# Council on Aging

## City of Attleboro ADA Transition Plan

June 2021

Institute for Human Centered Design

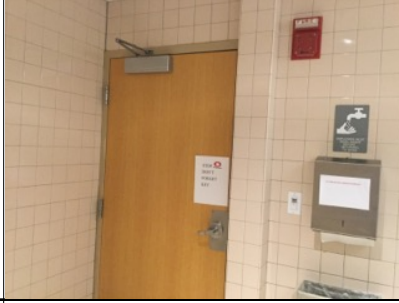
ID	Location	Floor	Room	Element	Type	Photo	Issues	Current Measure	Recommendations	Quantity	Price	Cost Estimation
<b>Approach and Entrance</b>												
<b>Off-Street Parking Lot or Garage</b>												
1	Accessible Parking	Ext.		Off-Street Parking Lot or Garage	Visitor		Sign not provided Sign does not have the designation "Van Accessible"	- -	Provide a sign with the bottom of the sign 60" min. above the ground and the top 96" max. above the ground at the accessible parking space closest to the entrance. Add the designation "Van Accessible" to the sign.	1	1000	\$1000
<b>Emergency Exit</b>												
2	Main Entrance	1		Emergency Exit	N/A		Tactile sign not provided at exit	-	Provide tactile exit signs with raised characters and braille at exit doors. Mount signs between 48"- 60" above the finished floor located on the latch side of the door.	1	232	\$232
3	Main Entrance	1		Emergency Exit	N/A		Tactile sign not provided at exit	-	Provide tactile exit signs with raised characters and braille at exit doors. Mount signs between 48"- 60" above the finished floor located on the latch side of the door.	1	232	\$232

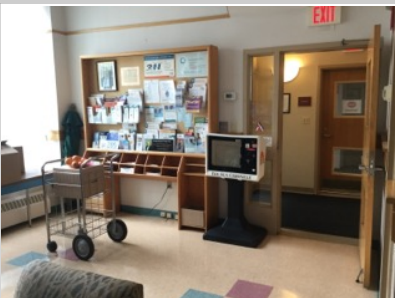
ID	Location	Floor	Room	Element	Type	Photo	Issues	Current Measure	Recommendations	Quantity	Price	Cost Estimation
6	Main Entrance	1		Emergency Exit	N/A		Illuminated Int. Symbol of Acc. not provided (MAAB)	-	When or if illuminated exit sign is replaced, provide a new illuminated sign with the International Symbol of Accessibility.	1	-	\$0
<b>Access to Goods and Services</b>												
<b>Interior Access Route</b>												
7	To Stair Near Main Entrance	1		Interior Access Route	N/A		Obstructed by protruding objects	4.5"	Relocate box.	1	256	\$256
8	Reception	1		Interior Access Route	N/A		Obstructed by protruding objects	7"	Relocate defibrillator out of the circulation path.	1	256	\$256
9	To Dining From Reception - Pamphlet Panel	1		Interior Access Route	N/A		Obstructed by protruding objects	4.5"	Relocate the shelving unit out of the circulation path.	1	256	\$256
<b>Doors, Doorways, &amp; Gates</b>

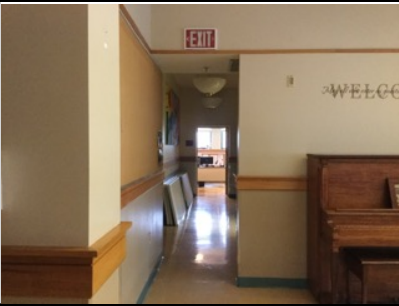
ID	Location	Floor	Room	Element	Type	Photo	Issues	Current Measure	Recommendations	Quantity	Price	Cost Estimation
11	TV/Dining Room	1		Doors, Doorways, & Gates	Other		Maneuvering clearance(s) not provided	-	Relocate newspaper dispenser out of the 18" that is required along the latch pull side of the door.	1	Labor	\$0
12	Men's Toilet Room	2		Doors, Doorways, & Gates	Toilet Room		Maneuvering clearance(s) not provided	14"	Relocate trash bin to provide 18" maneuvering clearance on the latch side of the door.	1	353	\$353
13	Men's Single-User Toilet Room and Women's Multi-User Toilet Rooms	1		Doors, Doorways, & Gates			Door requires > 5 lbs. of force to open	10 lbs.	Adjust closers so doors do not require more than 5 pounds of force to open.	2	Labor	\$0
14	Stair 2	2		Doors, Doorways, & Gates	Emergency Egress		Door requires > 5 lbs. of force to open	14 lbs.	Adjust closers so doors do not require more than 5 pounds of force to open.	1	Labor	\$0
